10CFR50.59 Safety Evaluation

**Addition of Three Manual Isolation Valves
within the RCGVS Process Vent Lines**

Florida Power & Light Company

JPN-PSL-SEMS-96-007

SIMPLIFIED FLOW DIAGRAM FOR THE UNIT 1
 REACTOR COOLANT GAS VENT SYSTEM
 (manually enhanced version)

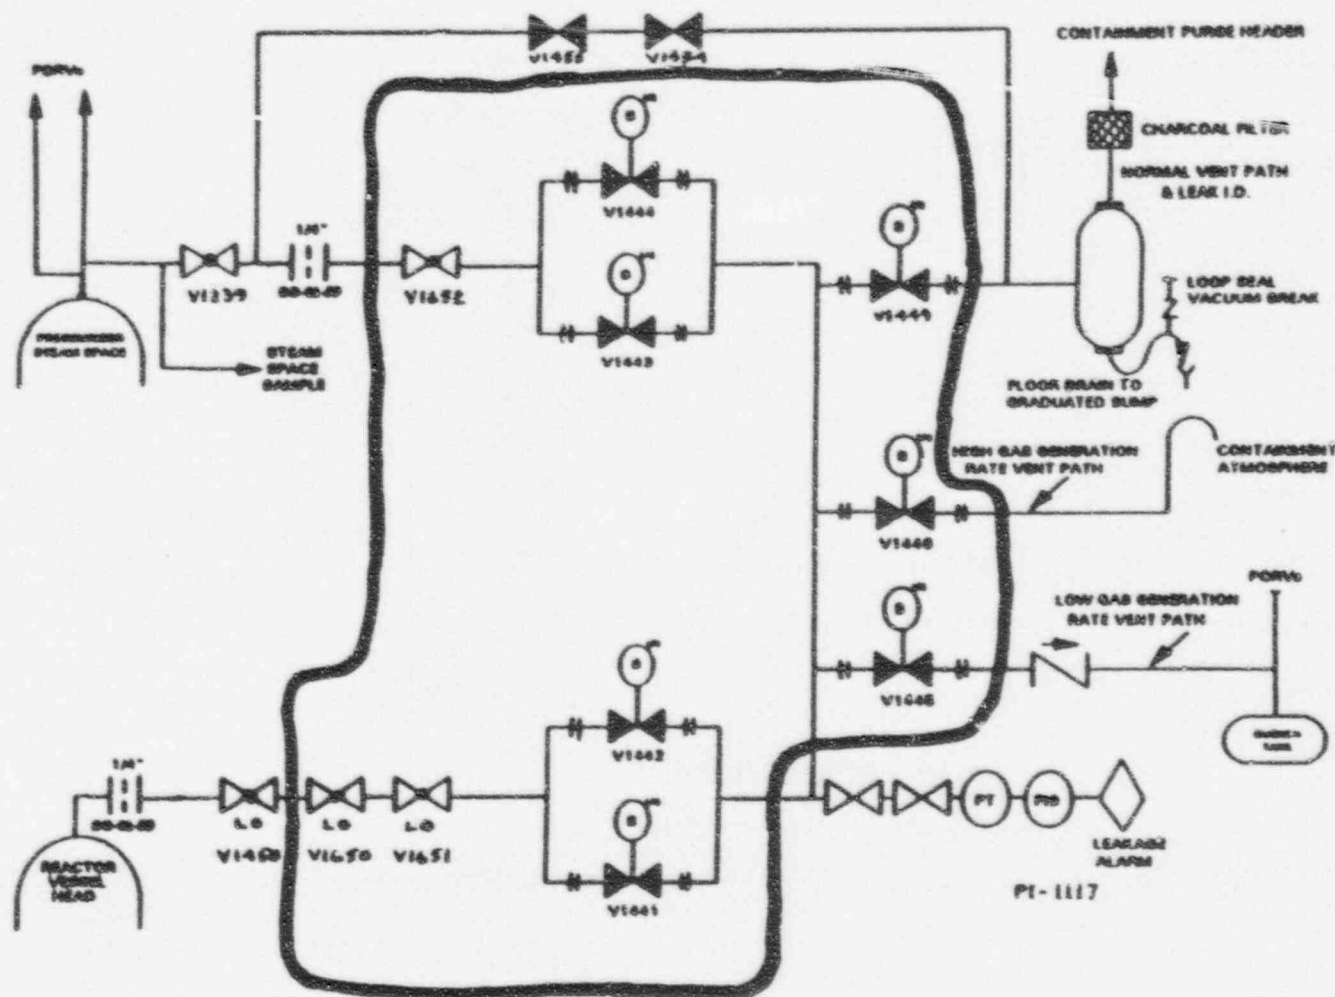
- 8.4 Provide appropriate guidance to St. Lucie Plant operators regarding the new installation of the three locked-open valves in the RCGVS vent lines (two manual valves on the Reactor head vent line and one on the Pressurizer vent line).

SIMPLIFIED FLOW DIAGRAM FOR THE UNIT 2 REACTOR COOLANT GAS VENT SYSTEM (manually enhanced version)

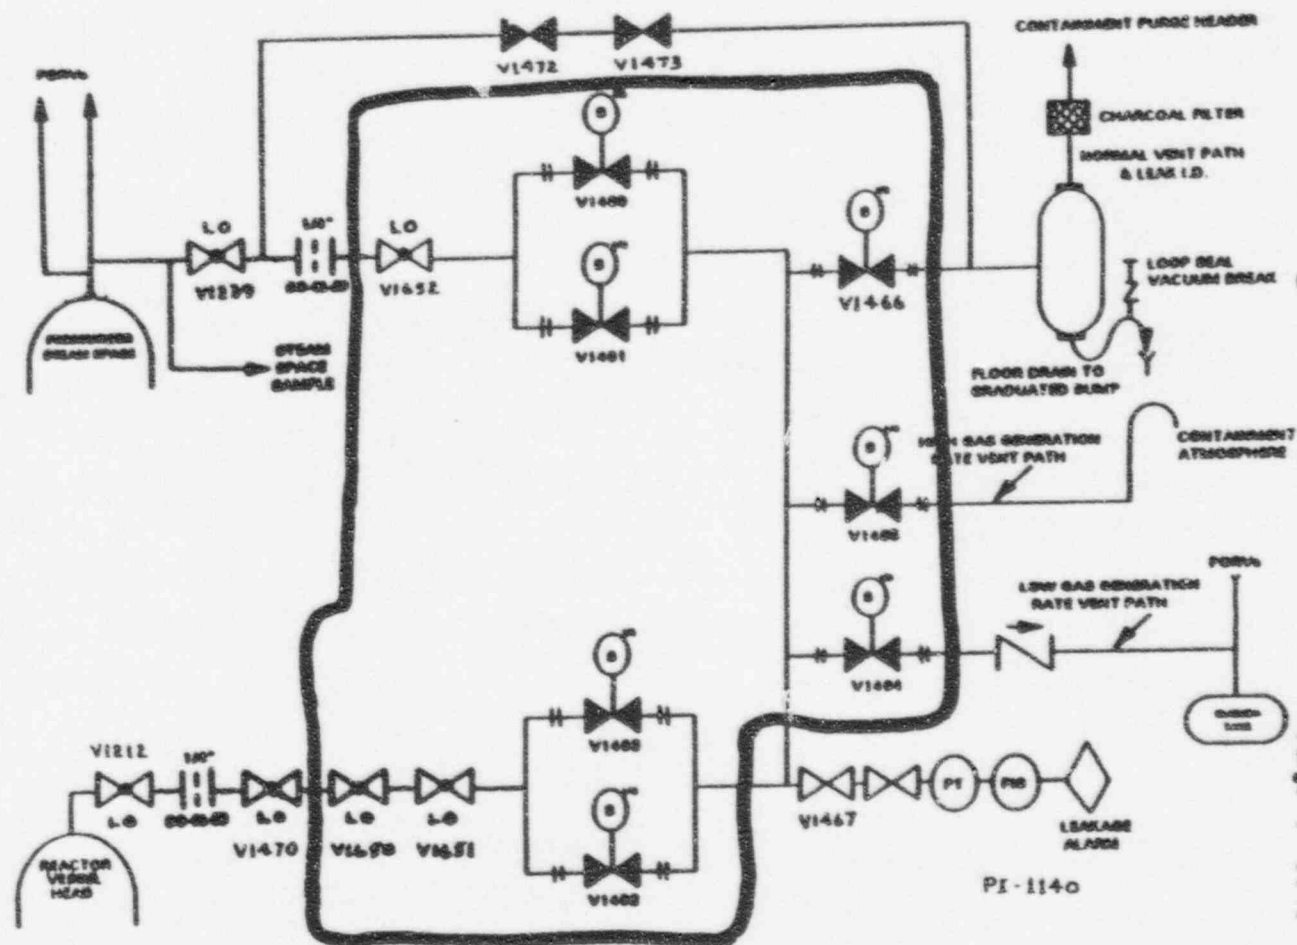
- 8.5 A revision to the FSAR's for St. Lucie Unit 1 and Unit 2 is presented within Attachments 11.3 and 11.4. These change packages eliminate both the discussion on leakage control and a duplicate figure for the Unit 2 RCGVS (and provides appropriate references to the RCS diagram given as Figure 5.1-4b within Section 5.1.2).

REACTOR COOLANT GAS VENT
SYSTEM - P&ID
FIGURE 4.3-7

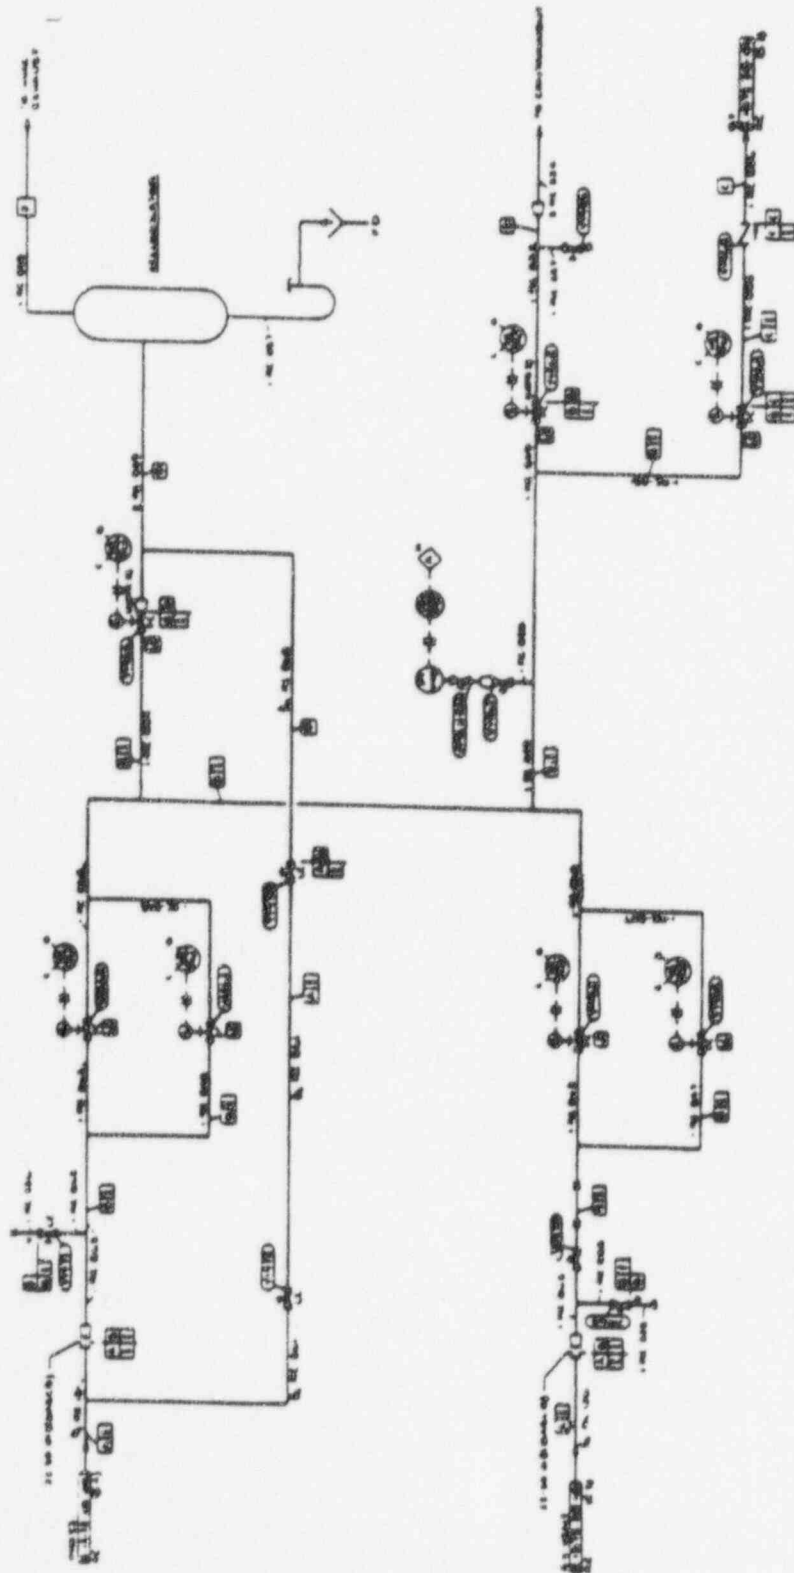
Figure 9.3.7

NOTE: Duplicate RCGVS figures appear in the Unit 2 FSAR (see Figure 5.1-4b and Figure 9.3-7). This is unnecessary and can lead to possible confusion regarding future FSAR updates. Figure 5.1-4b addresses an FPL referenced drawing and Figure 9.3-7 does not show any reference drawing. Therefore, from a control standpoint, Figure 9.3-7 shall be eliminated from the Unit 2 FSAR. Text changes will provide appropriate reference to the RCS Piping and Instrumentation Diagram given as Figure 5.1-4b (within Section 5.1.2).

As shown on Figure 9.3-7,  Change to 5.1-4b non-condensable gases are removed from either the pressurizer or reactor vessel through the flow restricting orifice and one of the parallel isolation valves and delivered to the quench tank or containment via their isolation valves. Venting under accident conditions would be accomplished using only one source (reactor vessel or pressurizer) and one sink (quench tank or containment atmosphere) at a given time.

Delete
